**EXHIBIT LIST FOR SUB 2019-005/EA 2019-017  
Preliminary Plat of Ridgeview**

### STAFF REPORT TO THE BENTON COUNTY PLANNING COMMISSION

FILE NO: **SUB 2019-005 (Preliminary Plat- 12 Residential Lots)**

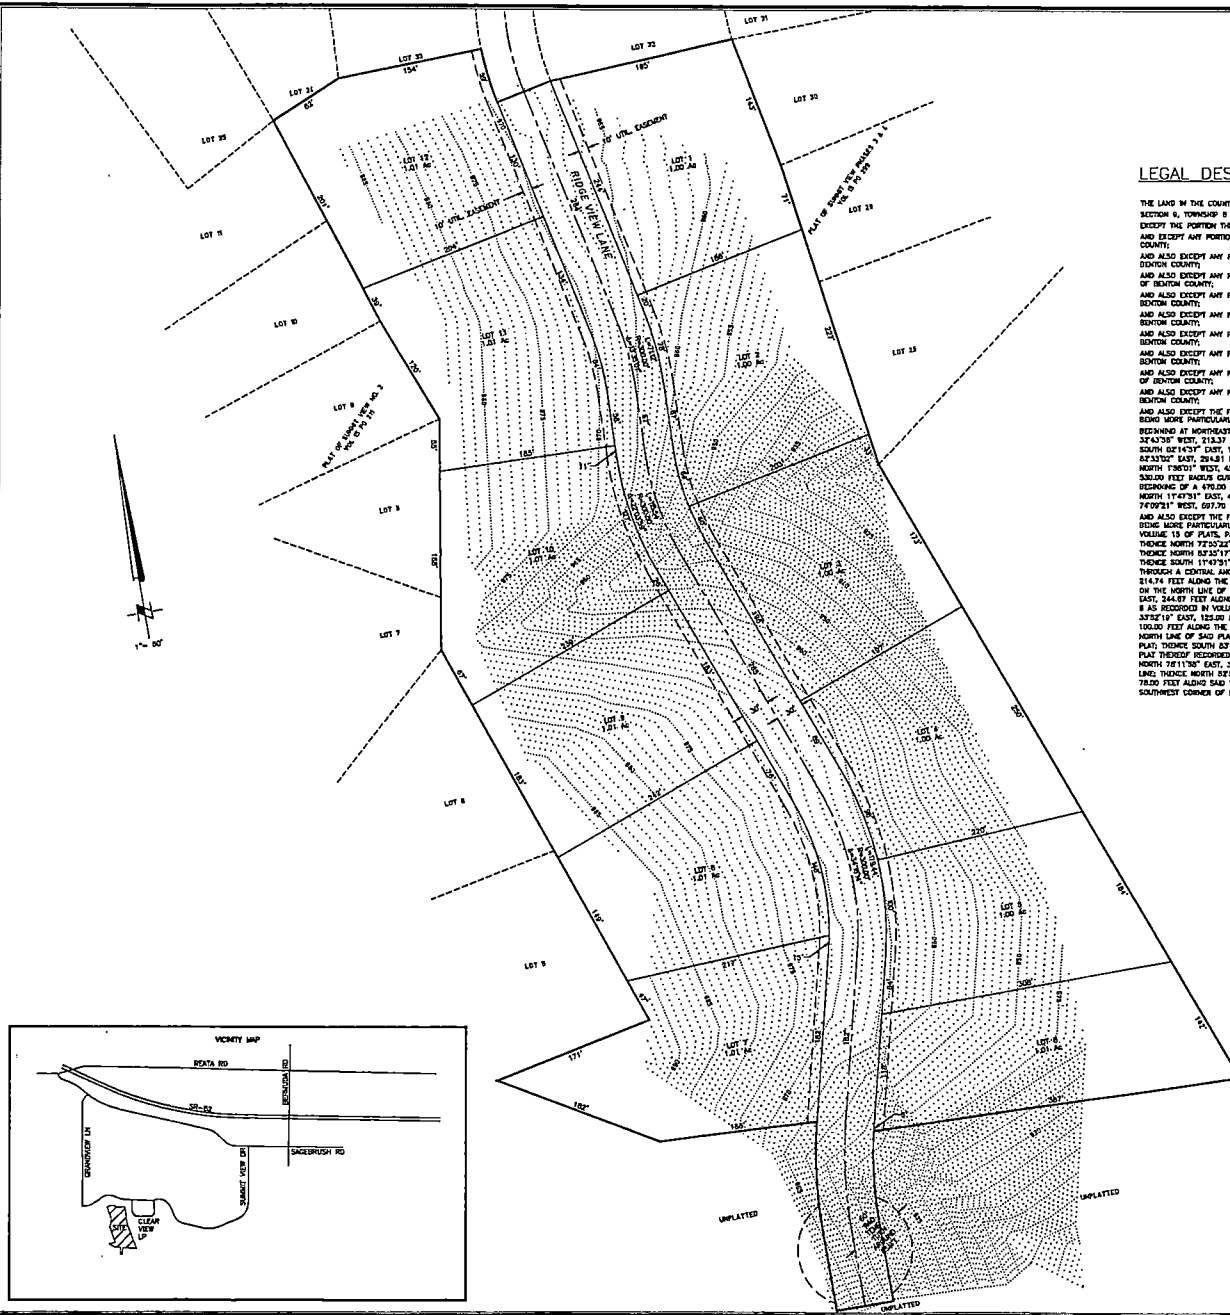
Also the plats attached didn't show any drainage easements designated. Maybe they haven't gotten to that point yet? But that is what we are looking for.

10. Extend contour lines to the edges of the plat
11. Show all drainage easements
12. Add the following notes to the face of the final plat
  - Benton County is not responsible for the maintenance or upkeep of any stormwater retention facility or drainage easements. All such maintenance and upkeep are the responsibility of the underlying property owner

**Benton County Fire Marshal's  
Review of Proposed Planning Applications****TO: Planning Dept****SUB: 19-005 & EA 19-017****Date Received 6-25-19 Date Returned 6-27-19****Applicant's Comments:**

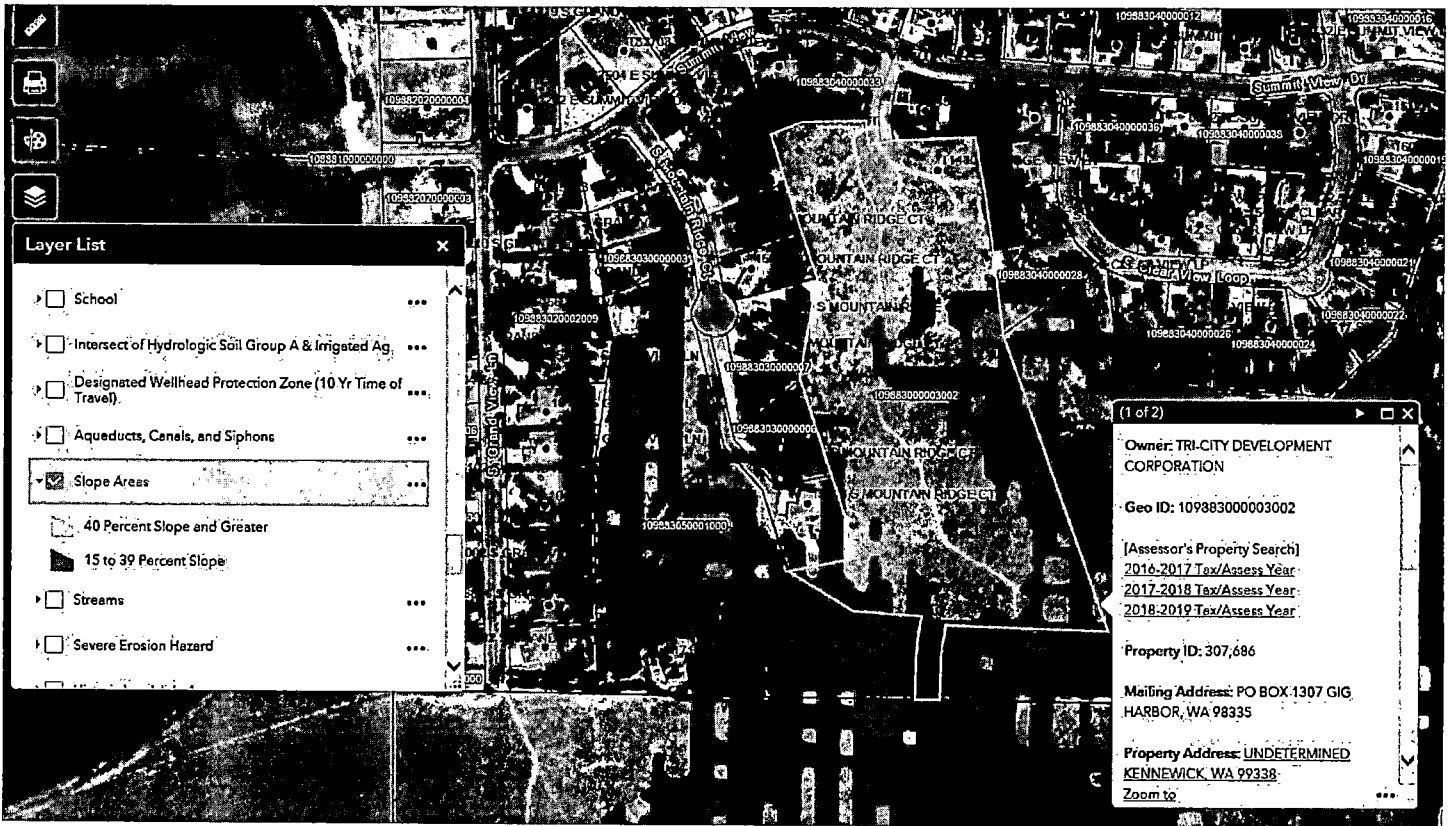
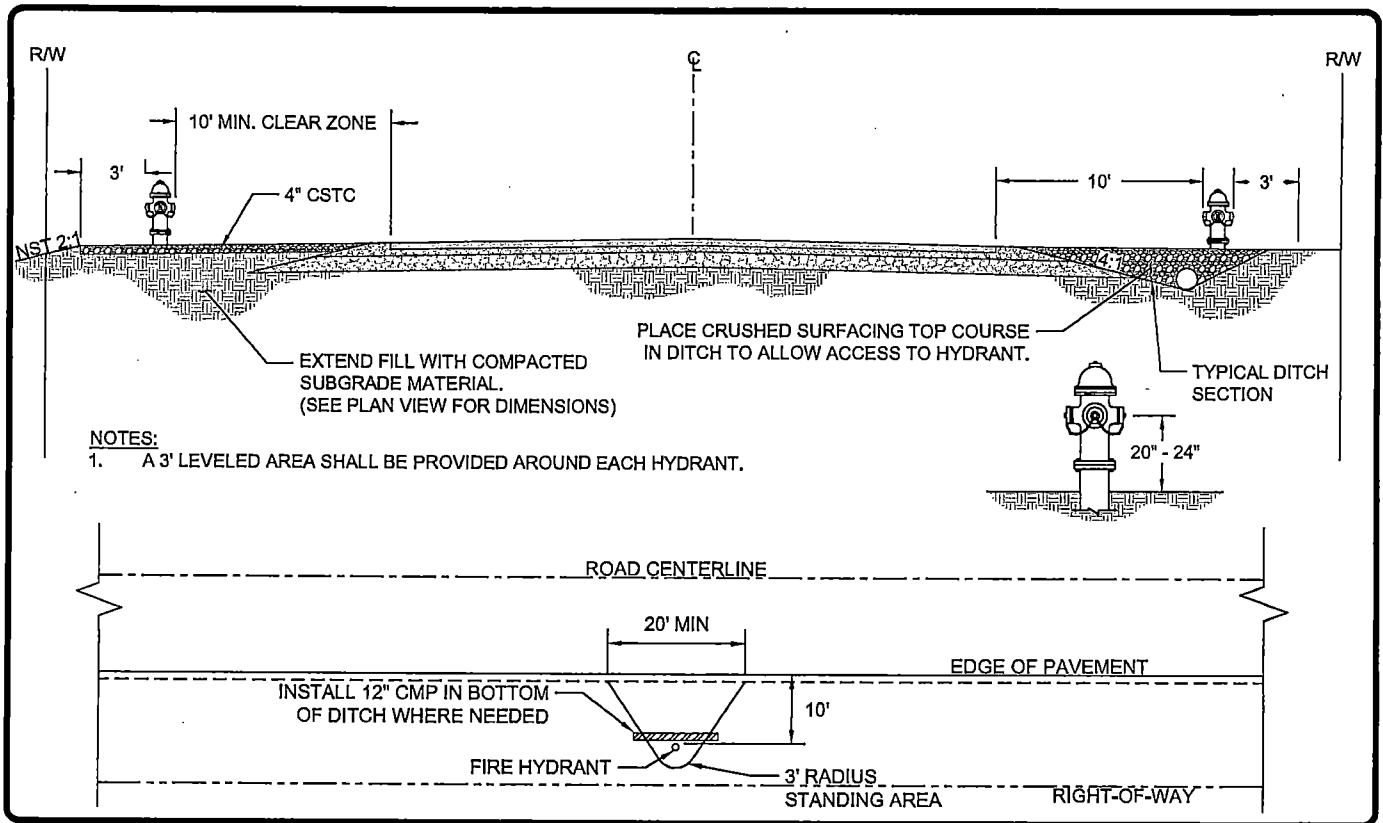
1. This parcel straddles a ravine with up to 39% slopes (pg.3). Homes whose exterior walls and decks face 15% slopes or greater shall have noncombustible siding.
2. All lots have Ridge View Lane frontage, which, within the plat, is 1,300' long and terminates in 120' diameter cul-de-sac.
3. Three hydrants have been located at
  - i. SW corner of lot 11.
  - ii. SW corner of lot 9.
  - iii. SW corner of lot 7.

1. Prior to preliminary plat approval, a letter from the water purveyor stating its willingness and ability to provide 500 gpm for 30 minutes at 40 psi static pressure and 20 psi residual, at normal peak instantaneous demands, is to be sent to the Benton County Fire Marshal.
